STAFF DEVELOPMENT COMMITTEE REPORT

To: Plan Commission
 Prepared By: Sam Hubbard, Development Planner
 Meeting Date: August 24, 2016
 Date Prepared: August 19, 2016
 Project Title: Kensington School
 Address: 840 E. Kensington Road

EXHIBIT A – PUD Approved Plan

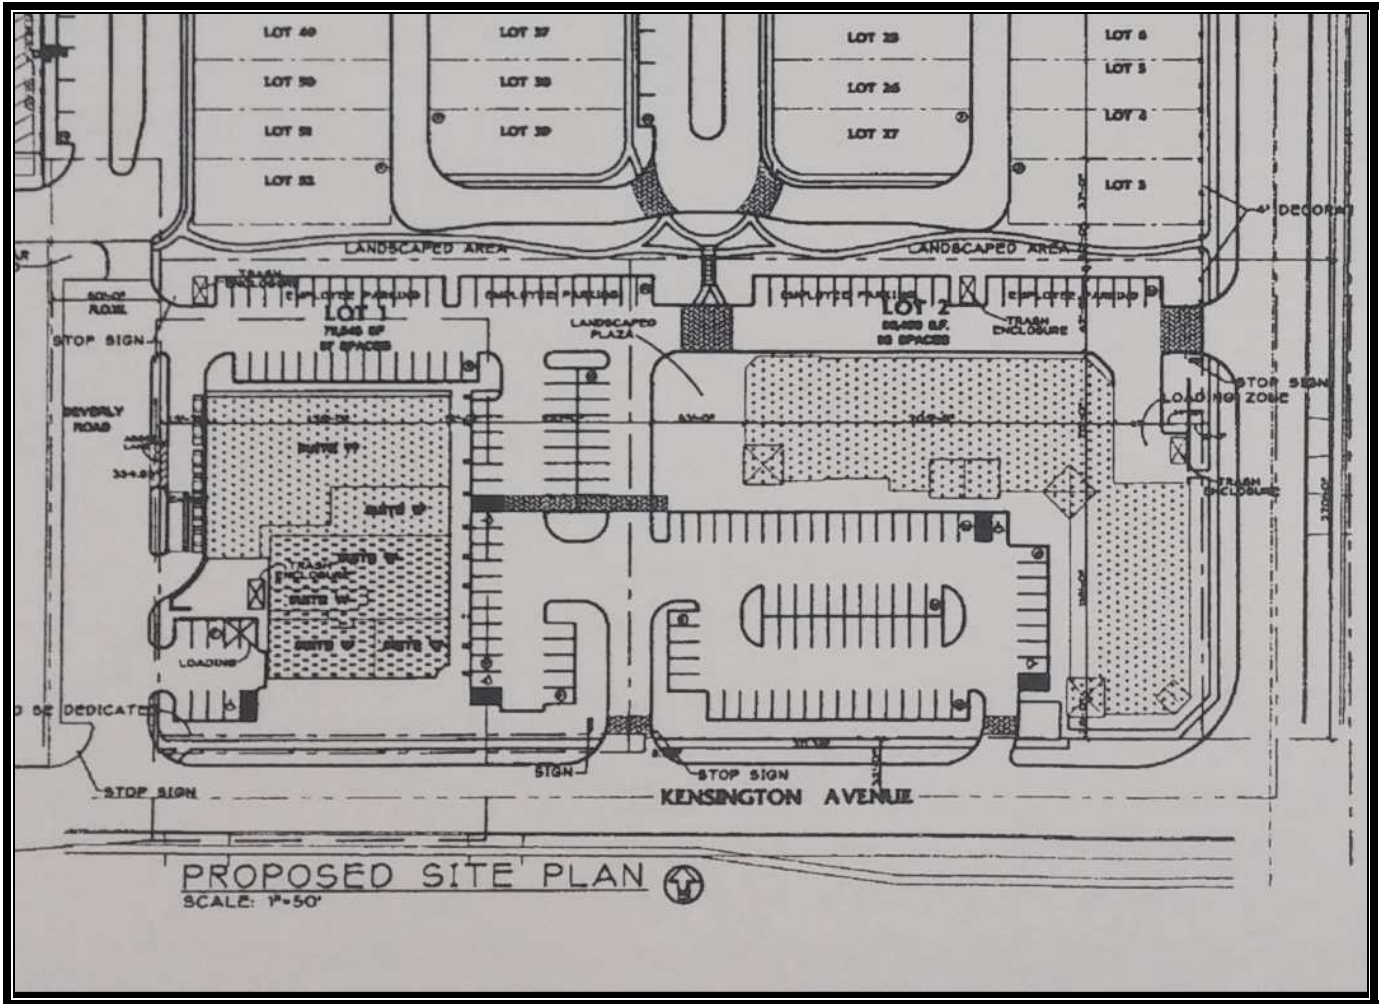
In addition to the Special Use, an amendment to the PUD is required as this proposed use and site plan are a substantial change from the PUD approved for the site, which was approved for an additional 23,000 square feet of commercial space with a plaza / focal point and pedestrian connection to the residential area to the north. The overall PUD was approved as a mixed use integrated development with a commercial strip to allow for multiple tenants / uses. See Exhibit A for the previously approved plan showing the commercial portion of the PUD.

EXHIBIT B – Previously Approved Plaza Area (in red)

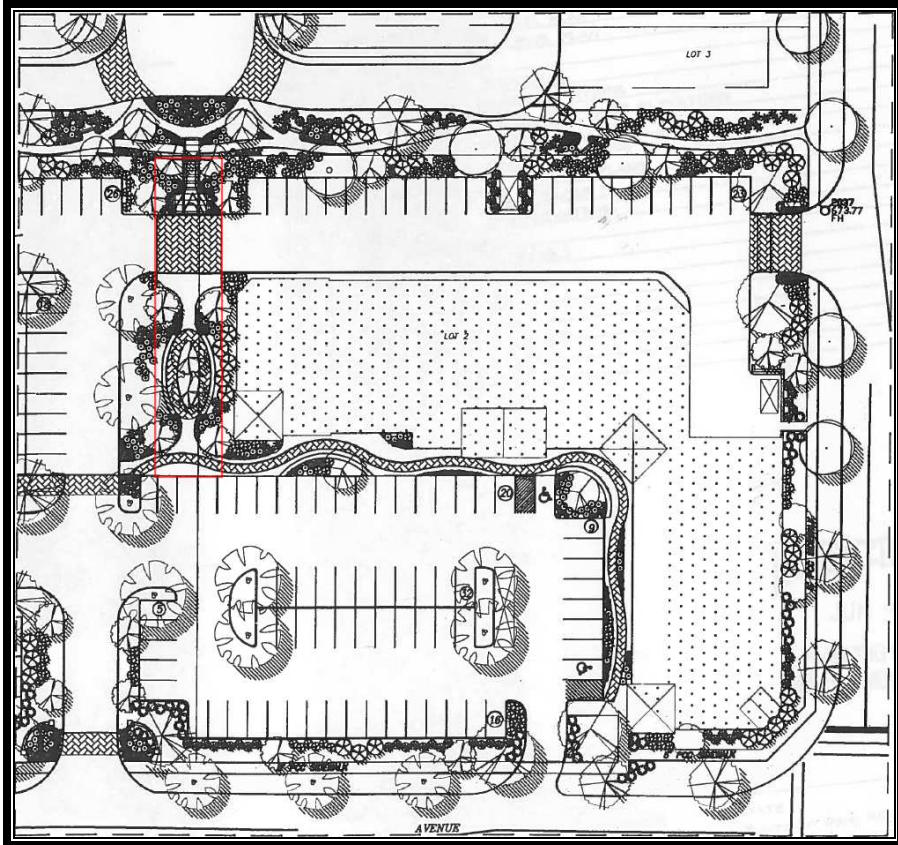
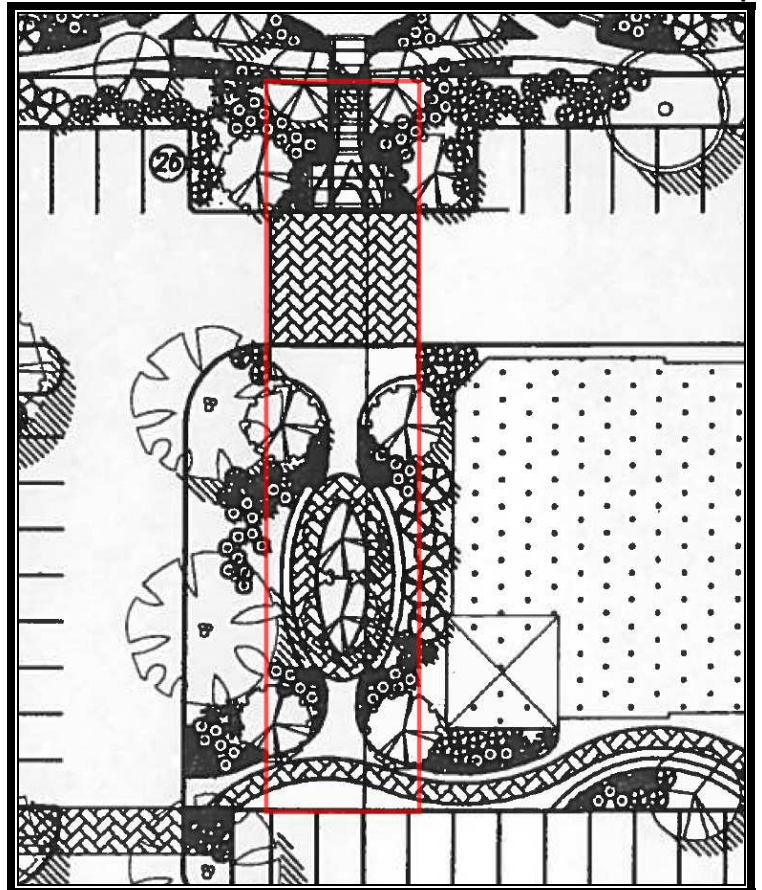
Finally, there is also a 25 foot wide Pedestrian Access Easement setback 31 feet from the west property line of Lot 2. This easement runs north to south 144 feet deep into Lot 2 from the north property line (please refer to 'Existing Easements' attachment page 2). The purpose of this easement is to accommodate a pedestrian plaza as part of the Lot 2 development, providing for a connection between the commercial property and the residential to the north, which is a significant component of the overall master plan for the Arlington Market redevelopment (a copy of the approved site plan for the commercial lots is included as Exhibit A and the approved pedestrian plaza area is shown in Exhibit B). The petitioner has included this element within their proposed plan, but has reduced the scope of the improvement from a plaza area to a walking path with landscaping, as well as slightly shifted the location to the west and reduced the width from 25' to 20'. However, the petitioners plan extends the length of the pedestrian pathway so that it connects down towards Kensington Road, whereas the original easement only went

about two thirds of the way down towards Kensington Road adjacent to the proposed shopping center. Staff is supportive of the revised pedestrian area given that the plaza was meant to serve the commercial uses on Lot 2 (as an outdoor eating area), which commercial uses will be substituted for the daycare. Additionally, although the width will be shortened, the length of the pathway will be extended through to Kensington Road. However, the petitioner must amend the easement to reflect its altered location, reduced width, and increased length.

2. The petitioner must amend the Pedestrian Access Easement to be a 20' wide easement that follows the proposed pedestrian pathway and runs from the northern property line down to the southern property line. This amendment must be recorded with the Cook County Recorder of Deeds, and proof of this recording must be provided prior to issuance of a building permit.
